March 18, 2021

**RE: Response to Comments on the 2020 Periodic Review Report
South Hill Dump, Town of Cortlandville, New York
CHA Project No.: 34236
NYSDEC Site No.: 712009**

**SOUTH HILL DUMP
SOUTH HILL ROAD
CORTLANDVILLE, NEW YORK**

***December 2020
Revised: March 2021***

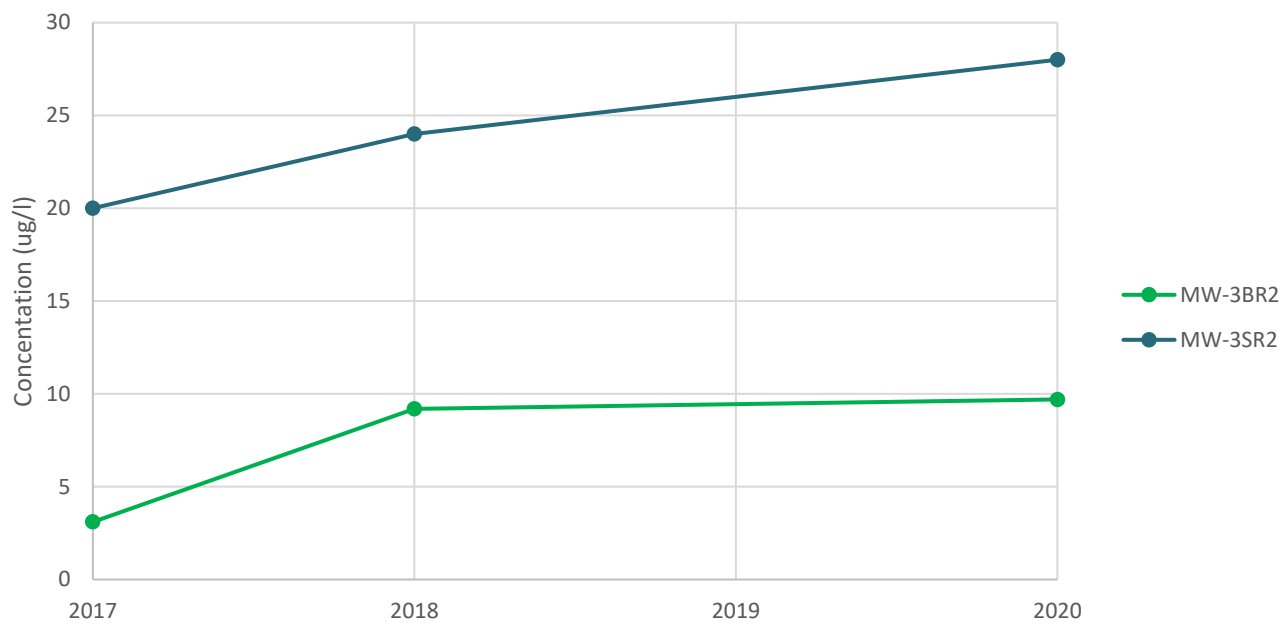
Comment 2: The PRR does not include any trend graphs for metals or volatile organic compounds (VOCs). Please include a set of trend graphs for VOCs and metals.

Response 2: *CHA has included time series graphs for the compounds that were detected above TOGS 1.1.1 in Appendix C.*
